Generic design assessment

UK EPR™ nuclear power plant design by AREVA NP SAS and Electricité de France SA

Final assessment report

**Gaseous radioactive waste
disposal and limits**

PCERsc6.4s3 Figure 1

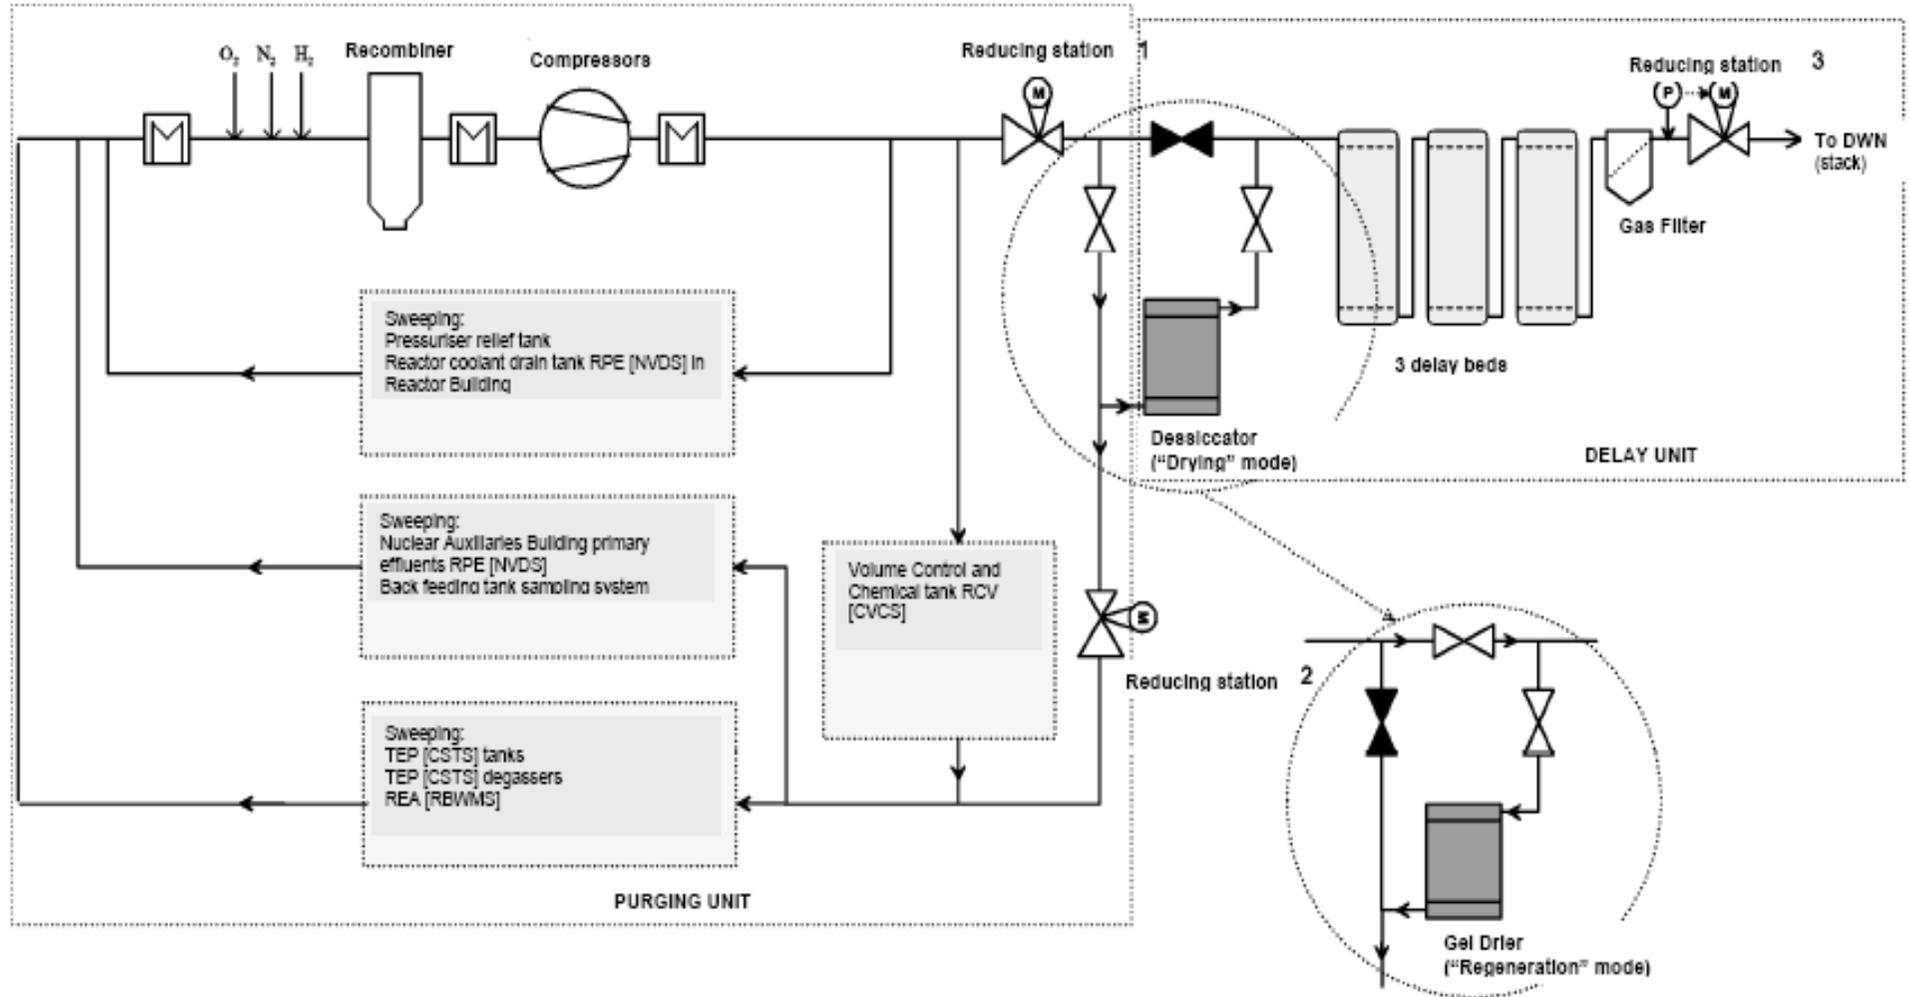
(PCERsc6.2s1.2.3.1, diagram PCERsc6.4s3 Figure 1 (page 80), reproduced in the Annex to this report)

PCERsc6.2s1.2.3.2 Figure 10

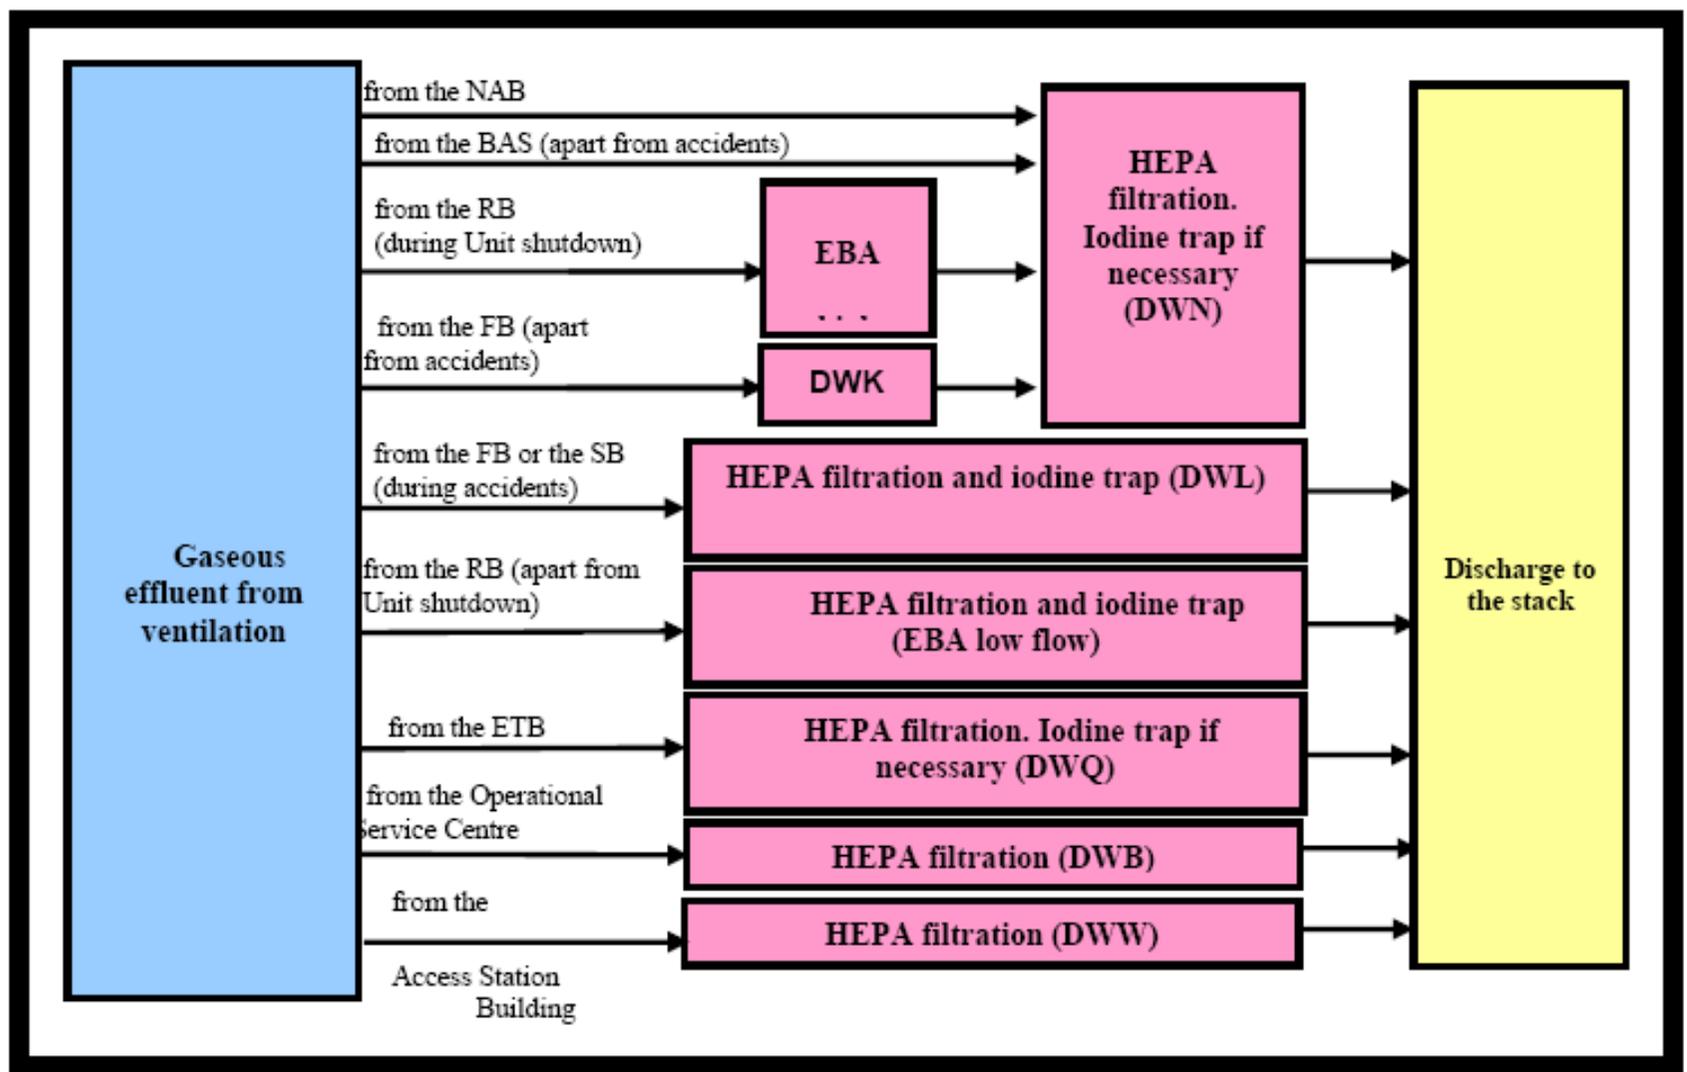
- b) The ventilation of buildings within the UK EPR that may be contaminated with radioactivity, in particular the Nuclear Auxiliary Building and the Fuel Building. Ventilation air that may contain radioactive particulates and gases, in particular iodine radionuclides (I-131 and I-133), is passed through filters and, if iodine detected, iodine traps before discharge. (PCERsc6.2s1.2.3.2 and Figure 10, reproduced in the Annex of this report)

- c) Gaseous effluent from the secondary circuit. This would be mainly air collected in the condenser vacuum system that could be contaminated with radioactivity, particularly tritium, in the event of a tube leak in the steam generators. The collected gases are filtered before discharge, the pathway from the NAB (Nuclear Auxiliary Building) is shown in PCERsc6.2s1.2.3.2 Figure 10 (reproduced in the Annex of this report).

PCERsc6.3s7.4.3.1 Figure 16

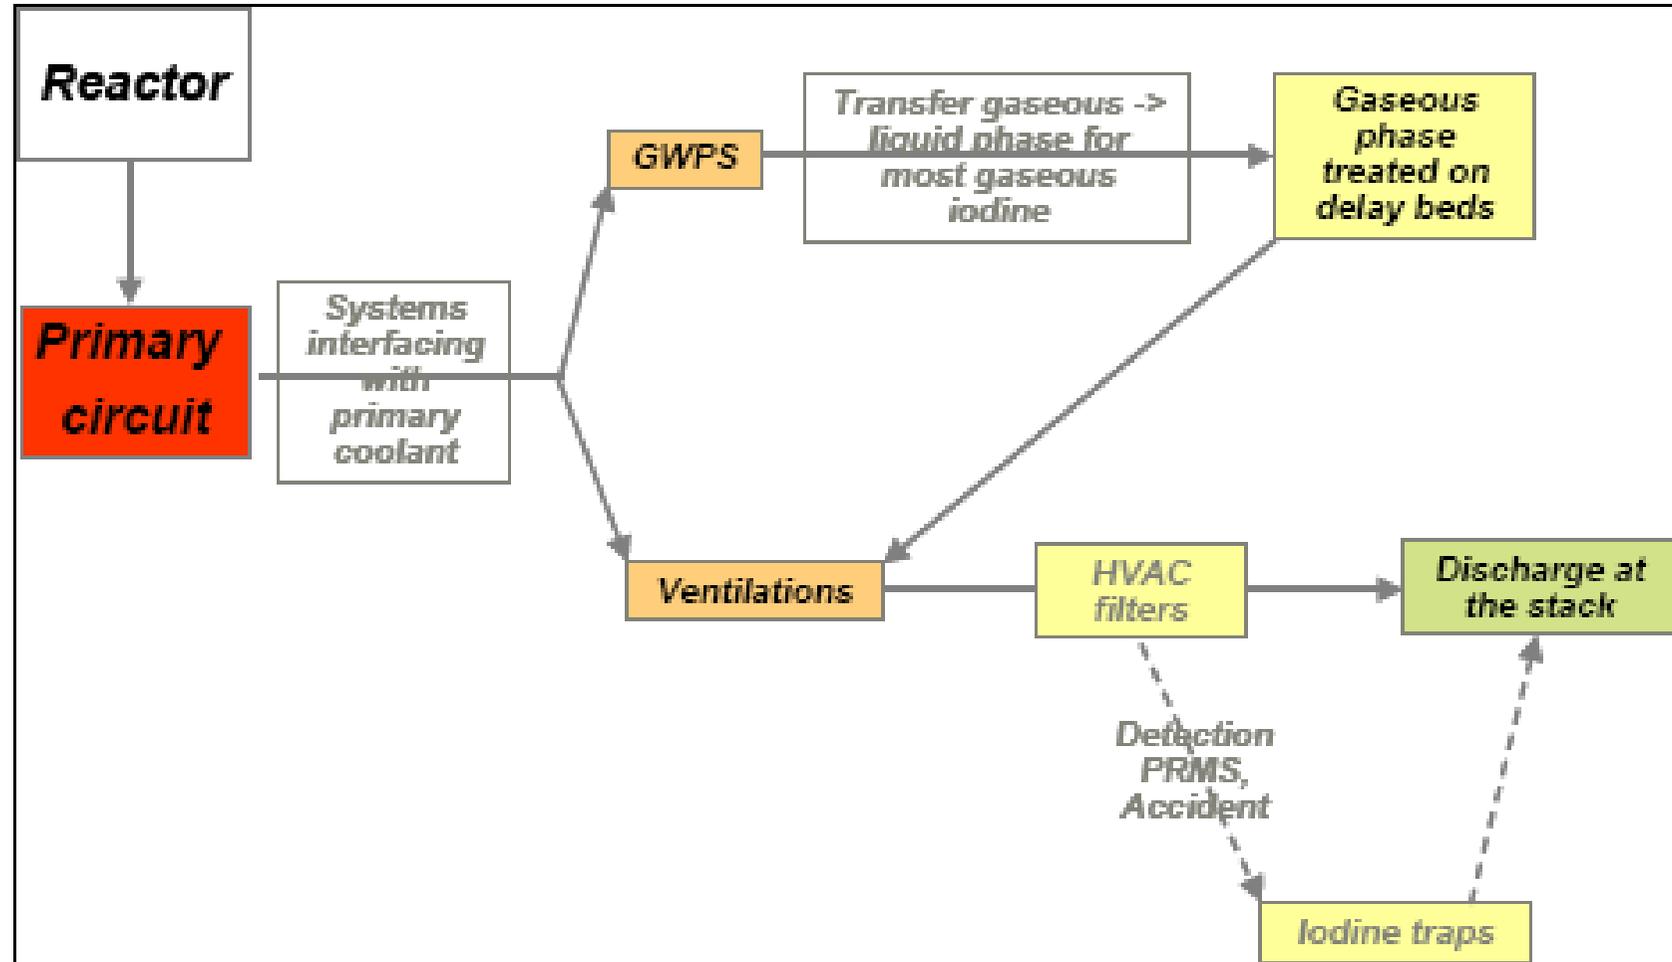
- 120 Any iodine radionuclides coming from leaks in the primary coolant circuit will enter the ventilation systems. These systems will send ventilation air to activated charcoal iodine traps if high iodine radioactivity is detected or as a precaution during certain operations or in case of accidents. (PCERsc6.3s7.4.3.1 Figure 16, reproduced in the Annex of this report).
